**Development Management
Planning Services**

59 Maresfield Gardens- Audit of Revised Basement Impact Assessment December 2012

From: Martin Cooper <Martin@gea-ltd.co.uk>
Sent: 16 March 2016 14:57
To: Hilary Shields
Cc: Mark Renshaw; Edd Rushton (EddR@lom-fdp.com); stephen.alder@jacksoncoles.co.uk; Steve Branch
Subject: 59 Maresfield Gardens - BIA
Attachments: 59 Maresfield Gdns Scheme 4 South Wall_SLS Pool.pdf

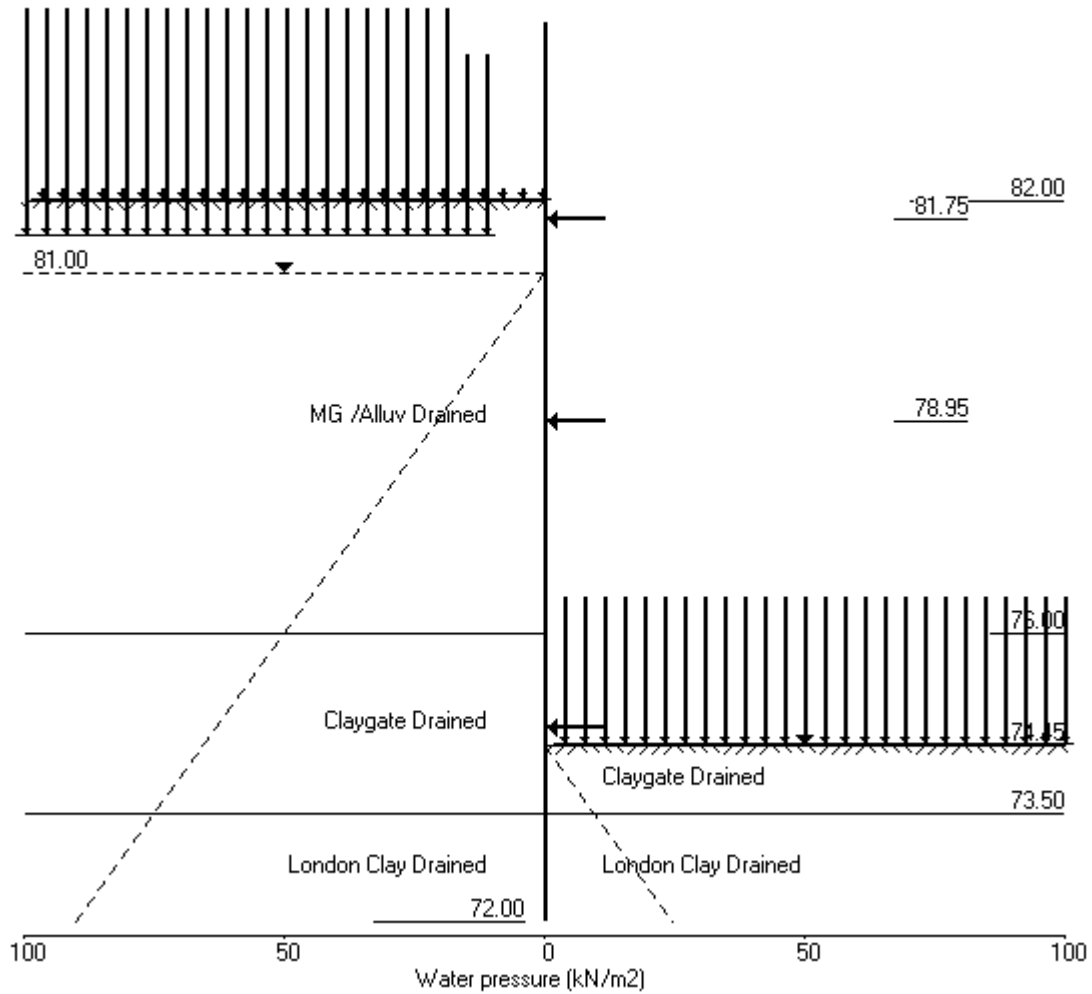
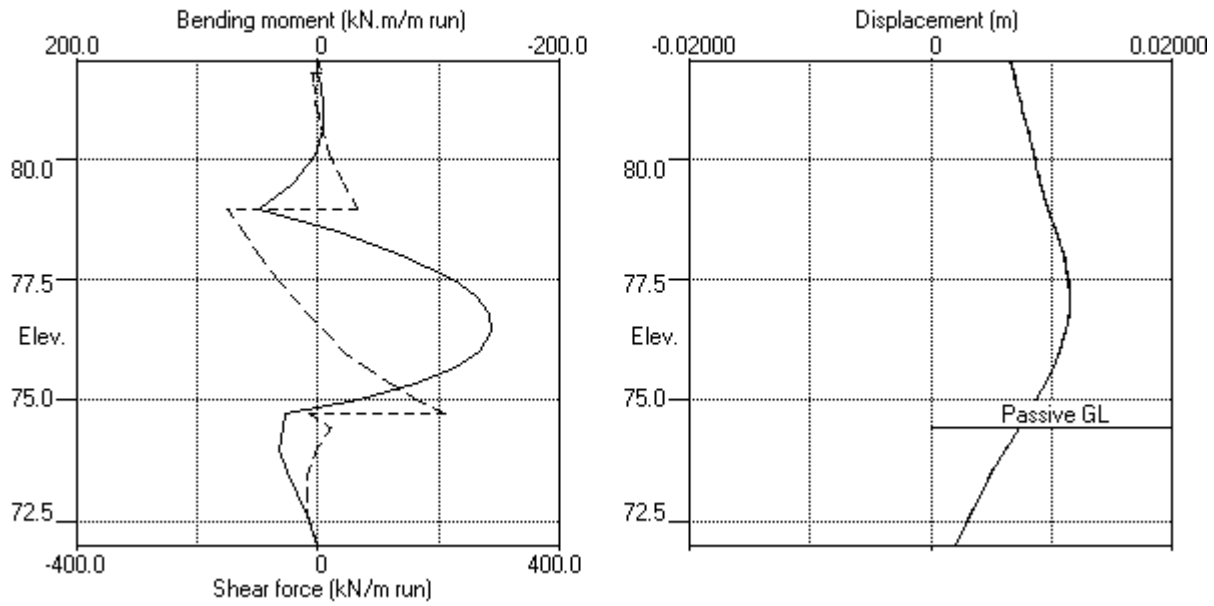
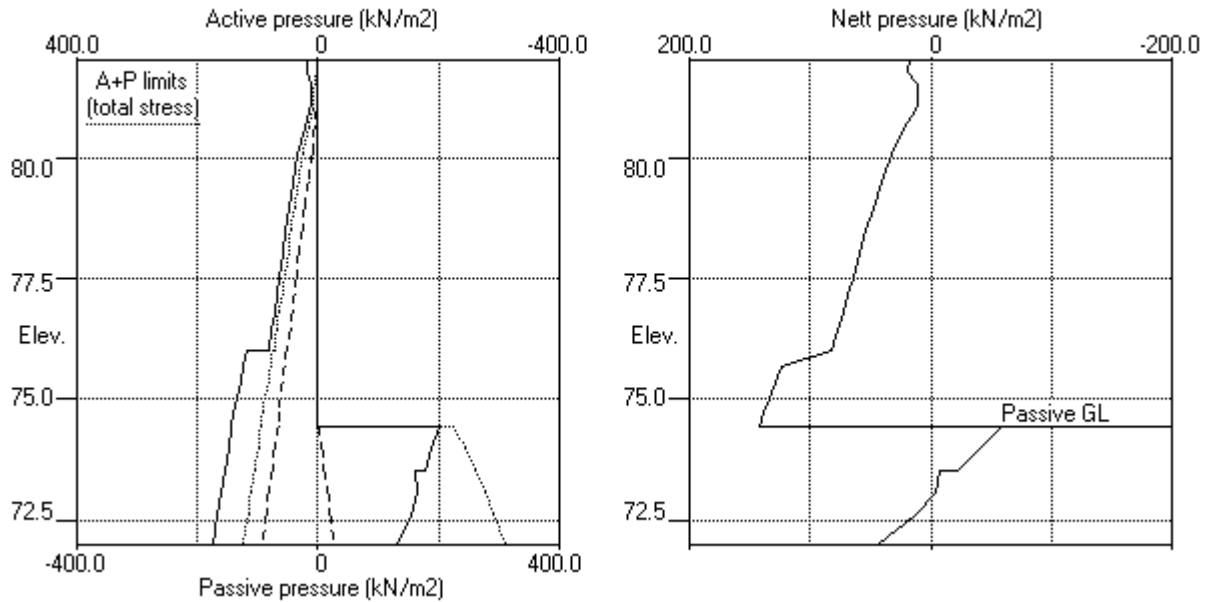
2. The deeper dig for the swimming pool appears to extend significantly past the end wall of 57 Maresfield Gardens. However, there is no Wallap analysis for the deeper dig with the building surcharge. Please consider how this may affect the wall and ground movement assessment.

2. The deeper dig for the swimming pool appears to extend significantly past the end wall of 57 Maresfield Gardens. However, there is no Wallap analysis for the deeper dig with the building surcharge. Please consider how this may affect the wall and ground movement assessment.
A new Wallap analysis has been undertaken for the South wall with the deeper excavation for the pool whilst still supporting the adjacent No 57 Maresfield Gardens. This run is appended and has indicated no increase in pile depth but an increase in maximum bending moment from 65 kNm per pile to 124 kNm per pile. There is a slight increase in the maximum deflection from 10 mm to 12 mm but the movements remain within those in the movement curves adopted within the XDisp analysis. There is therefore no change to the predicted damage category.
